LITWORNIA ASSOCIATES, INC.

Re: West Essex Highlands, Inc. PB 24-01
Township of West Orange, Essex County, NJ
Block 179, Lot 32
LAI 2024-006

RE: RESIDENTIAL SITE IMPROVEMENT STANDARDS (RSIS) – TRAFFIC REVIEW

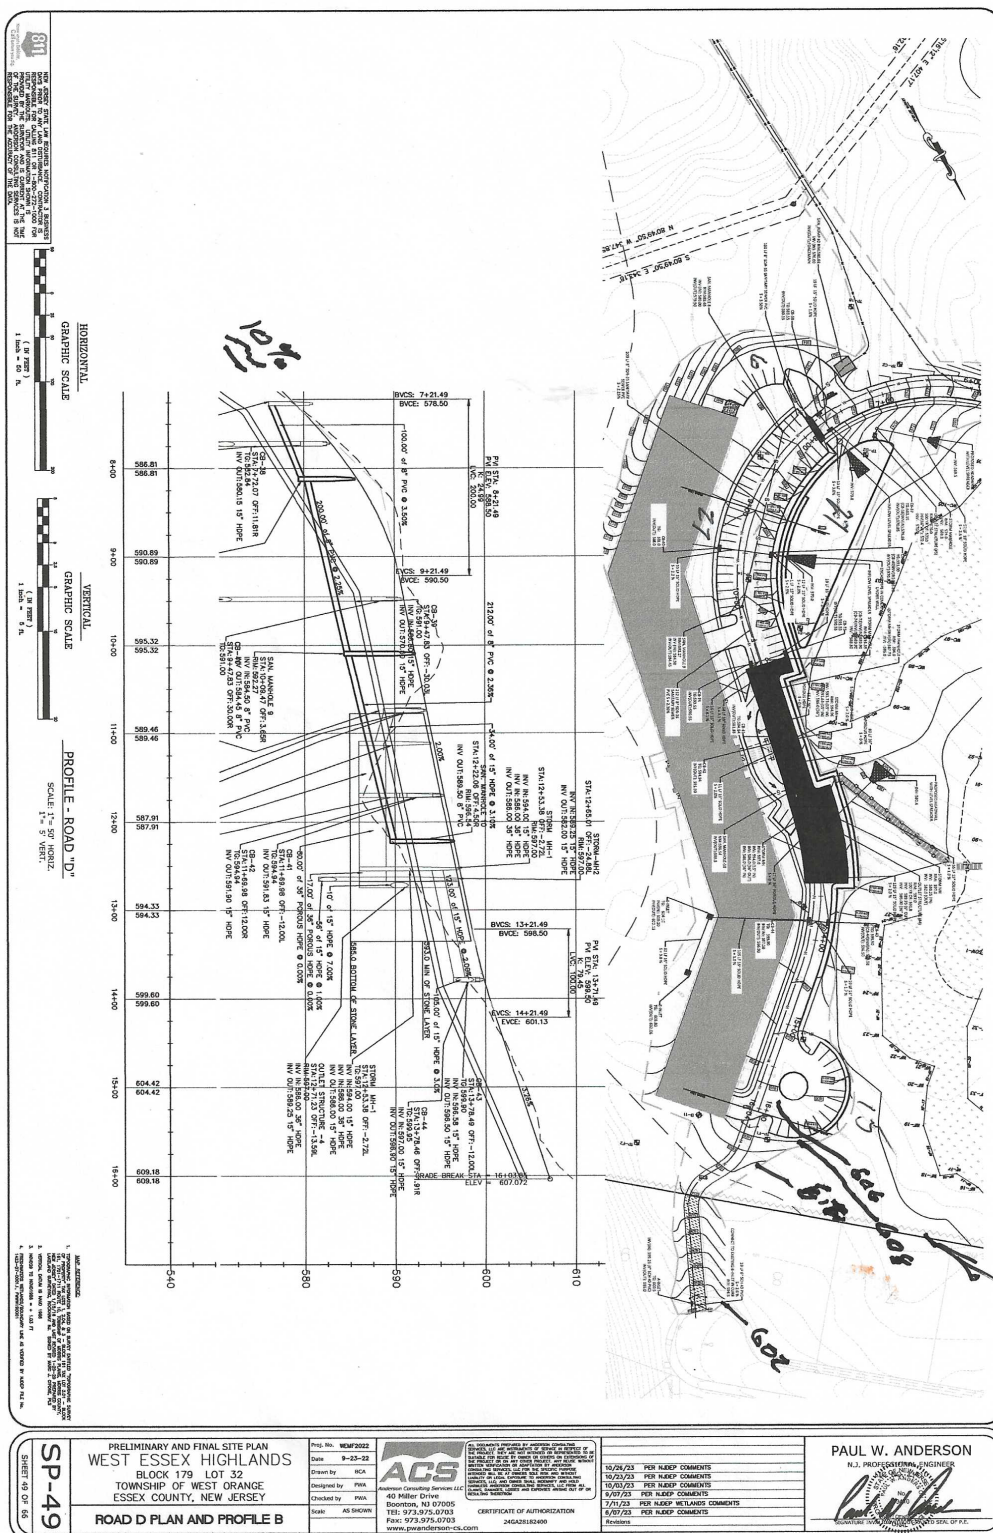
Road "D" has sections where the travel lane grade is 10% which exceeds Table 4.6 Requirements (See Attachment 1 Table 4.6) grade limits for a major collector and is on the upper edge of a minor collector. Since Road "D" is a driveway and a dead end cul-de-sac this slope is objectionable. Further, the lower garage exit into Road "D" appears to intersect in the 10% slope region. Considering this is essentially an intersection, Table 4.6 shows a limit of 5% slope on either street of the intersection but Road "D" is sloped 10%. This is a huge safety issue as the slope is twice what is allowed.

5. Road slope on Road D is 10% plus it passes parking entrance on that slope. Violates RSIS and is dangerous in icy conditions. Vehicles cannot stop at the driveway on this slope.
